HISTORIC AND DESIGN REVIEW COMMISSION

HDRC CASE NO: 2015-168
ADDRESS: 606 NOLAN
LEGAL DESCRIPTION: NCB 561 BLK 1 LOT E IRR 50.44 FT OF 2
ZONING: R6 H
CITY COUNCIL DIST.: 2
DISTRICT: Dignowity Hill Historic District
APPLICANT: Terry Moore
OWNER: Terry Moore/ Remuda Asset 1 LLC
TYPE OF WORK: Construct new carport and landscaping
REQUEST:

The applicant is requesting a Certificate of Appropriateness for approval to:

LANDSCAPE/ SITE PLAN (REVISED)
SCALE: 1/8" = 1'-0"

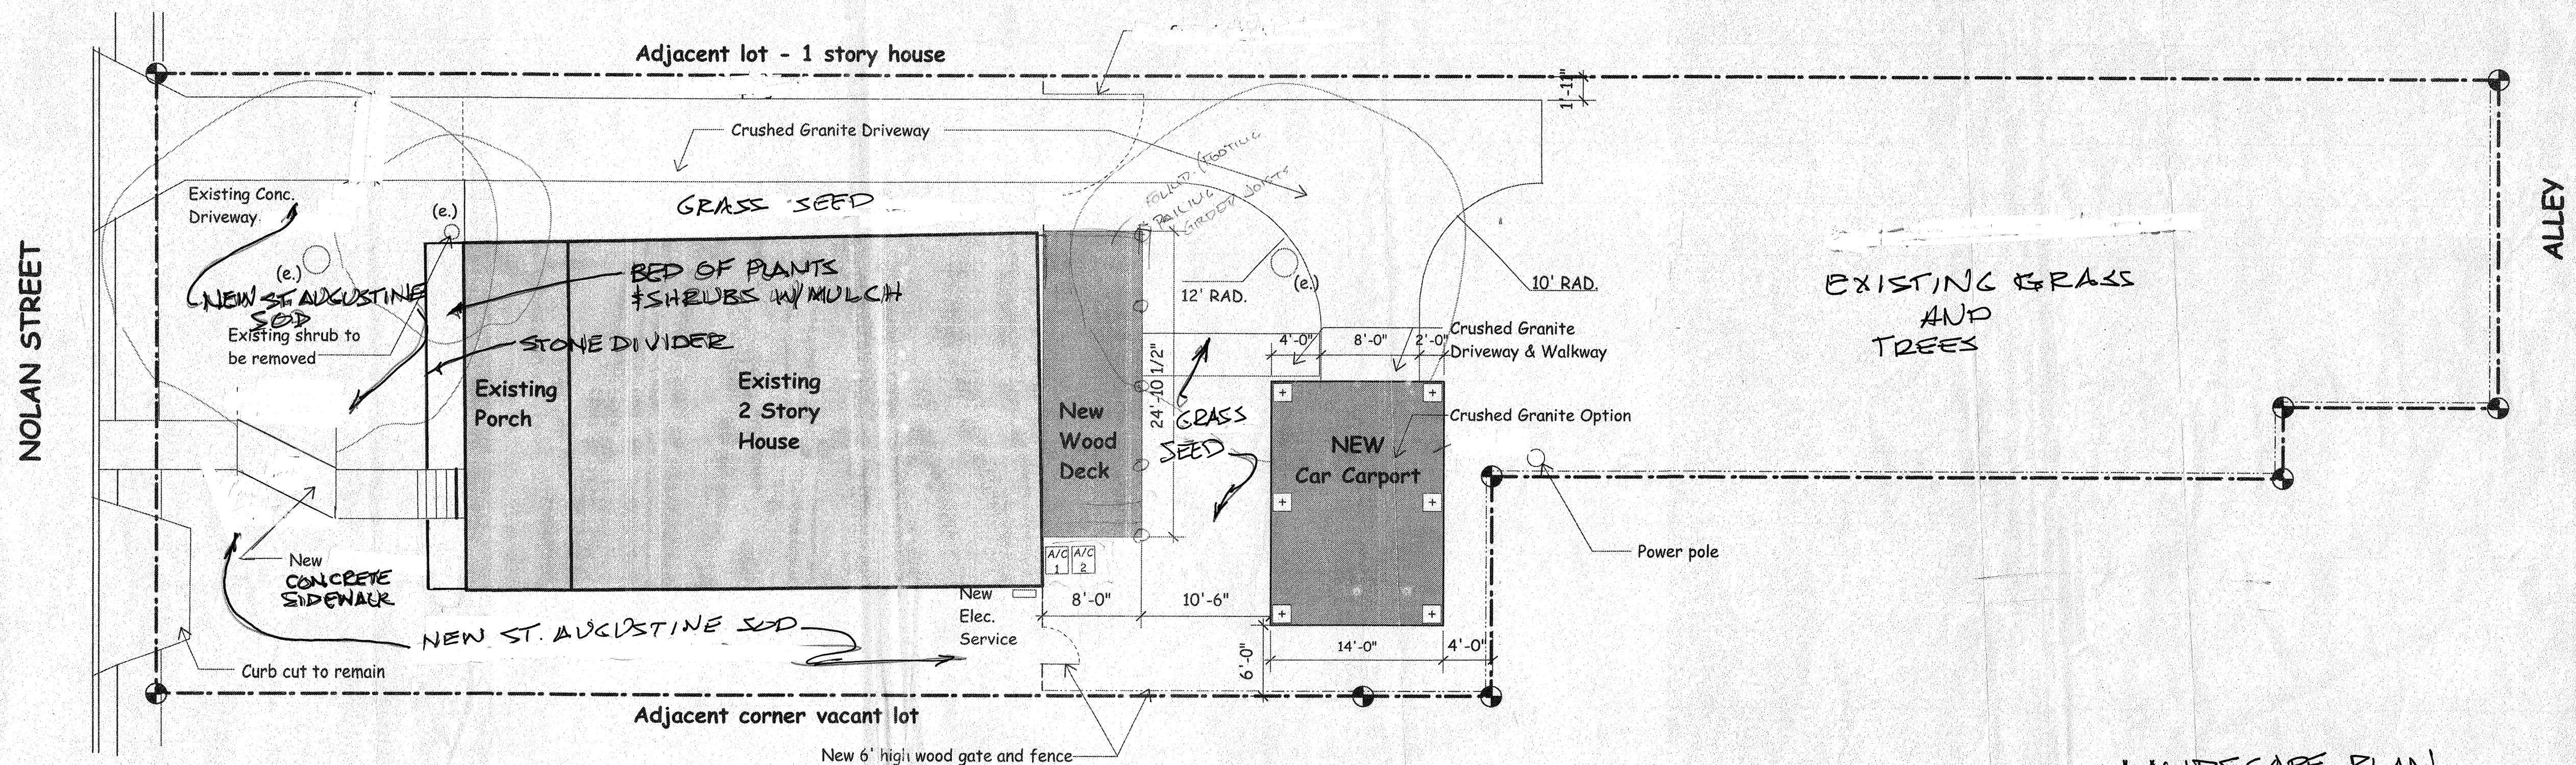
- b. According to the Guidelines for New Construction, new outbuildings should match the predominant orientation of garages and outbuildings on the block. The proposed carport is set behind the main structure with a curved driveway leading around the back of the house. Linear driveways with the carport or garage structure at the end are typically found in the Dignowity Hill Historic District. Locating the carport at the end of a linear driveway would be more appropriate.

Staff recommends approval of items 1 and 2 based on findings a-c with the stipulation that the driveway is linear and the carport is placed at the end of the driveway.
